# UNITED STATES PATENT AND TRADEMARK OFFICE

APPLICATION NO.	FILING DATE	FIRST NAMED INVENTOR	ATTORNEY DOCKET NO.	CONFIRMATION NO.
10/791,997	03/02/2004	Daniel J. Coster	APL1P290/P3186	4300
22434	7590	05/30/2006	EXAMINER	
BEYER WEAVER & THOMAS LLP P.O. BOX 70250 OAKLAND, CA 94612-0250			PAPE, ZACHARY	
			ART UNIT	PAPER NUMBER
			2835

## Office Action Summary

### **DETAILED ACTION**

**Fig 1**

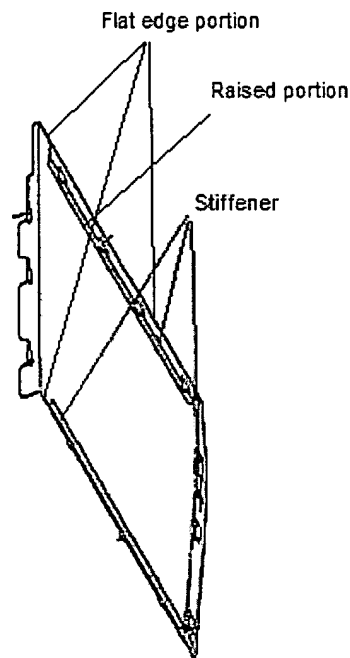
With respect to claim 38, Chen et al. further teaches a stiffener (See present office action Fig 1 below) that is attached to an inner surface of the planar access door, the stiffener being configured for insertion into a recess within the access opening when the access door covers the access opening.

With respect to claim 45, Chen et al. further teaches that the removable access door (80) includes interior and exterior surfaces, the interior surface having a flat edge portion and a raised portion inside the flat edge portion (As illustrated in present office action Fig 1 above).

to edge of the planar panel (As illustrated in POA Fig 1 above, the inner and outer surfaces are flat from edge to edge), and a stiffening member attached to the inner surface of the planar panel (The stiffener is folded over from the edge of the panel), the placement of the stiffening member forming the flat edge portion and raised portion of the removable access door (As illustrated in POA Fig 1 above).

With respect to claim 56, Chen et al. in view of Lin et al. teaches the limitations of claim 35 above, and Chen et al. further teaches that the removable access door (80) includes a planar panel with flat surfaces extending end to end (See POA Fig 1 above) but both Chen et al. and Lin et al. are silent as to they material from which the planar panel and housing are formed. Ahn teaches the conventionality of making both a cover and a housing of aluminum (Paragraphs 53, and 60). It would have been obvious to one of ordinary skill in the art at the time the invention was made to combine the teachings of Ahn with that of Chen et al. and Lin et al. to provide an easily manufacture-able chassis.
